KONE LIFTS LTD TYPE MR12 BRAKE BOW ARMS

KONE LIFTS LTD	Subject <u>MR12 BRAKE BOW ARMS.</u>			CODE: SN 04.05.16 Page 1 of 5 SAFETY CATEGORY A	
DEPT. TECH.SUPP	DATE 7.2.97	COMPILED BY A J Shiner	CHECKED V J Kaura	APPROVED <i>AS</i>	ISSUE A

MR12 BRAKE BOW ARMS

Diagram 1. Brake bow arms

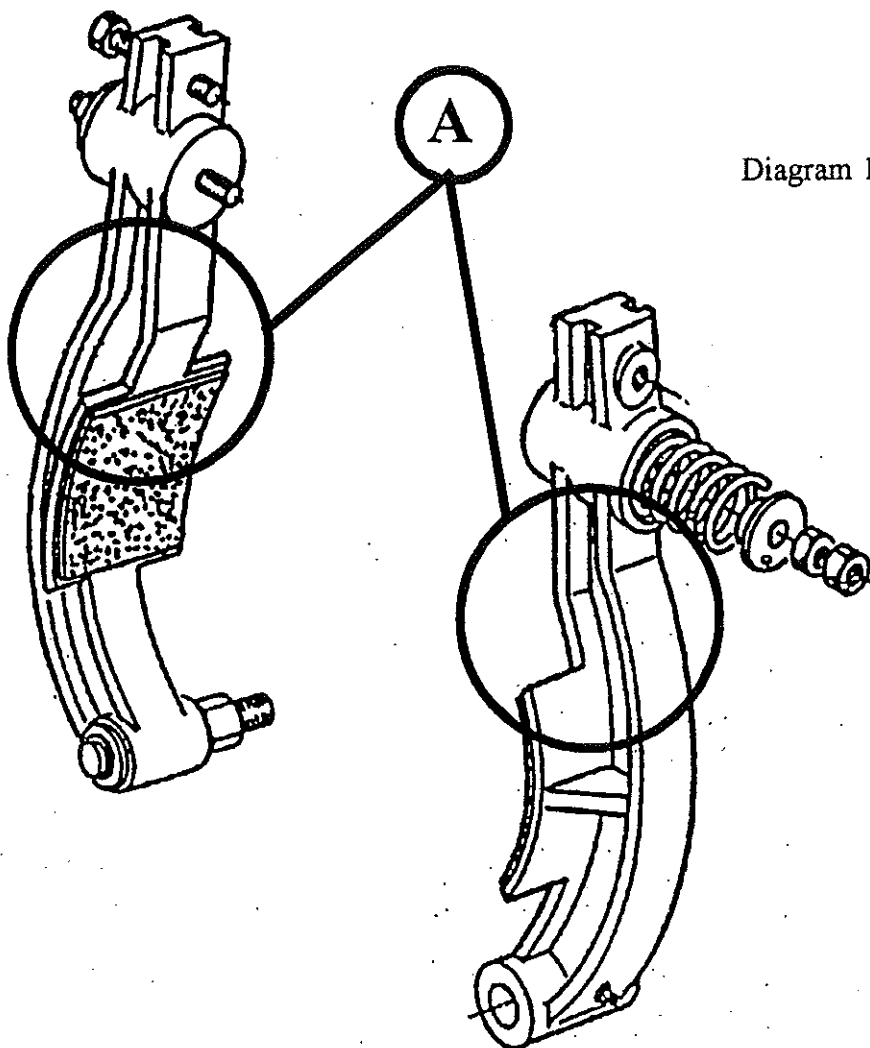
In the reported cases of the cracked and broken brake bow arms the fracture has occurred in the position marked A in the diagram 1 in Appendix 1. In single and two speed elevators there is a tripping hazard due to bad levelling if there is only one brake bow functioning. If both brake bows fail then the elevator would run out of control to the top or bottom of the shaft dependant on the loading in the car.

The fractures that have been found originate from the casting process and not from normal service.

Each brake bow arm is to be inspected visually at the point marked A in diagram 1. If there are signs of fracture the brake bow is to be replaced.

- Stop elevator.
- Carry out inspection on one brake bow at a time.
- Open brake bow. Use service instructions as detailed in section 3.3.3. below.
- Inspect carefully (with a torch) the brake bow surface for cracks in the area marked A in Appendix 1.
- Close brake bow arm Use service instructions as detailed in section 3.3.3. below.
